IN THE MATTER OF:
**DEVELOPMENT CONSENT ORDER APPLICATION BY NATIONAL
GRID ELECTRICITY TRANSMISSION (“NGET”)**
FOR THE NORWICH TO TILBURY PROJECT (“THE PROJECT”)

**FURTHER SUBMISSIONS ON BEHALF OF PYLONS EAST ANGLIA
LIMITED (“PEAL”)**

Norwich to Tilbury National Grid Pylon Project

**Landscape Sensitivity Appraisal:
Colne Valley**

These options are represented in the following scale drawing of the trench sections:

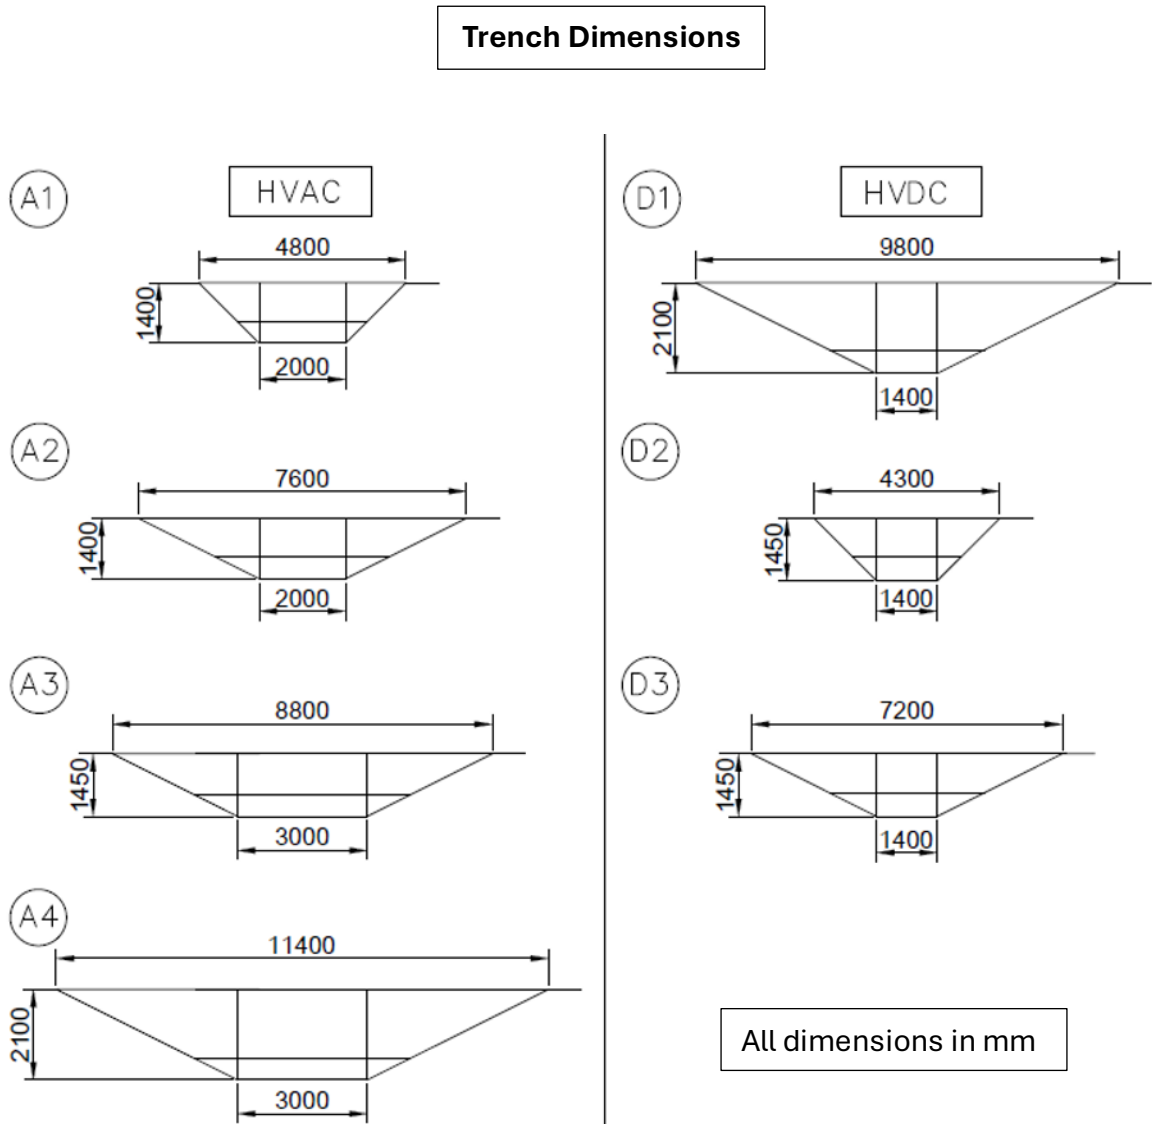
The following points are highlighted:

- For the Norwich to Tilbury project, the Applicant states the HVDC trench width at the surface to 9800 mm. The corresponding dimension quoted for the EGL 3&4 project is 1400 mm. However, the EGL information does highlight that if the excavation is splayed to eliminate the risk of collapse, the surface width could extend to approximately 7400 mm, assuming a slope angle of 1:2. As the trench width calculates at 7200 mm, with a 1:2 slope angle and a 1400 mm base width⁶, for accuracy and consistency this figure has been used in this document instead of the approximate figure of 7400 mm quoted for the EGL 3&4 project.

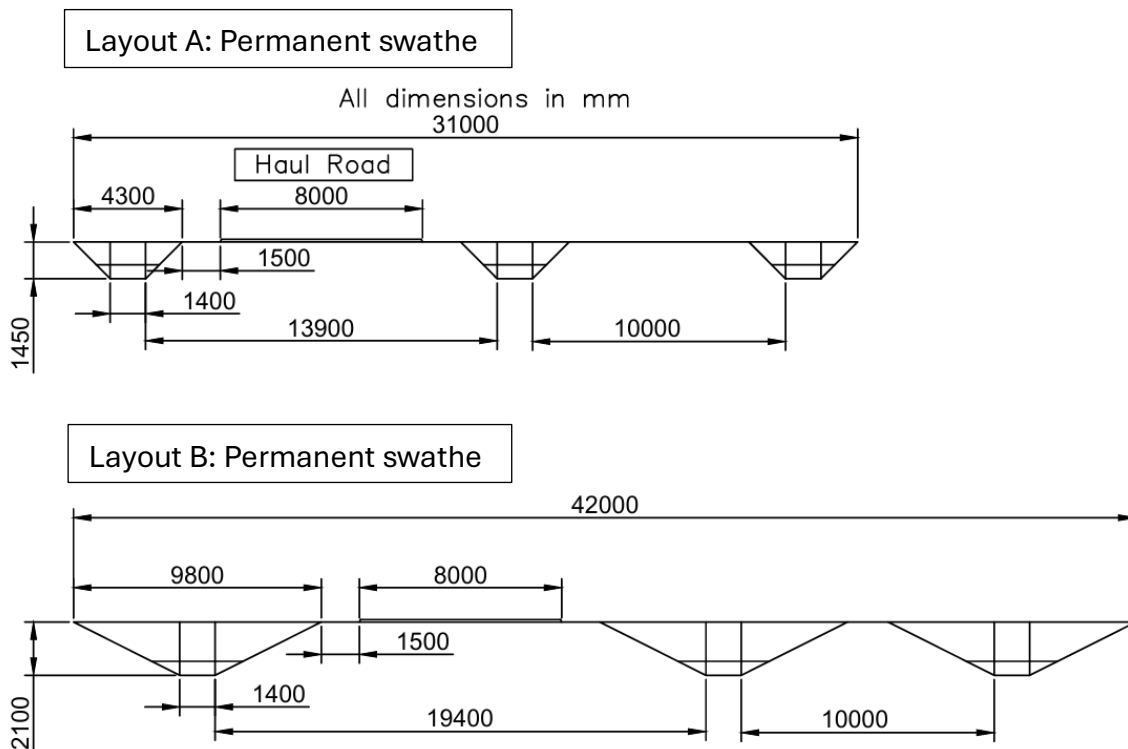
D2: HVDC underground trench as specified by the Applicant for EGL 3&4 but with a slope angle of 1:1 to match the slope angle specified by the Applicant for the Norwich to Tilbury project HVAC underground trench in [REP1-003]

As can be seen, this results in a substantial reduction in the width of the permanent swathe and, due to the considerable reduction in material stockpiles, there would be corresponding reductions in the construction swathe. To verify the data, other examples were cross-referenced.

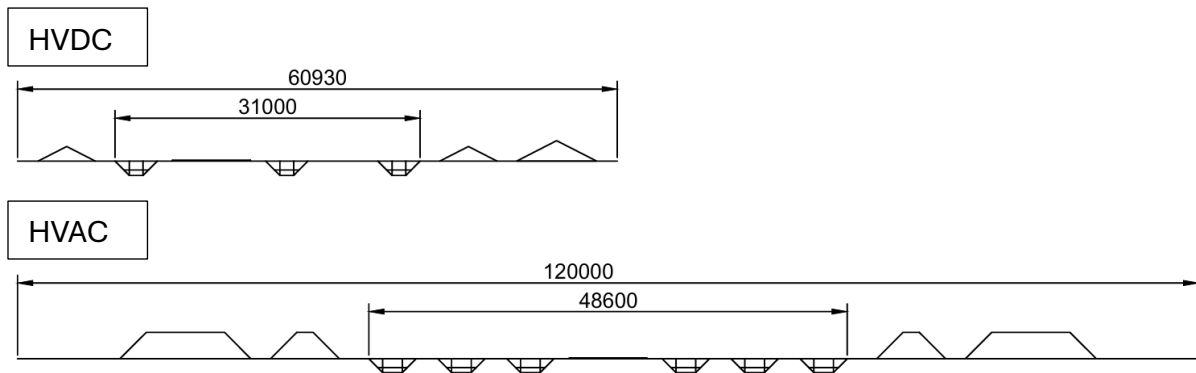
Calculations performed by the Applicant relating to the reduction in temporary land take are then outlined and the Applicant then concludes that the “additional land take

required for HVDC converter stations is only balanced in land take terms with a Project length of 25.7 km”.

It is very important to highlight initially that the HVDC solutions proposed by PEA, whether they be onshore or offshore, have always applied to the full length of the Norwich to Tilbury route. This assumption was implicit in the Green Book work carried out by PEA [REP2-056] and the point has been reiterated. For example, in the “Deadline 2 Submission from Pylons East Anglia Ltd” [REP2-054], the following is stated: “*We have never asked for HVDC undergrounding only in the Dedham Vale. That misrepresents our position. We are fully aware that HVDC for short distances is impractical and that HVDC is a long-distance solution well suited to the entire route from Norwich to Tilbury, ideally without a break.*”

It is noted though that the Applicant’s calculations show that the land take is balanced “*with a Project length of 25.7 km*”. This is a relatively short distance and is close to the figure of 21 km quoted by the Applicant for the HVAC underground sections, noting also for example that in the Dedham Vale NL that the length is effectively increased by a double width section required to accommodate the wide HVAC swathe. If the calculation is repeated with the reduced HDVC construction swathe of 61 m, as suggested in this report, the figure at which the land take is balanced reduces to 15.2 km.
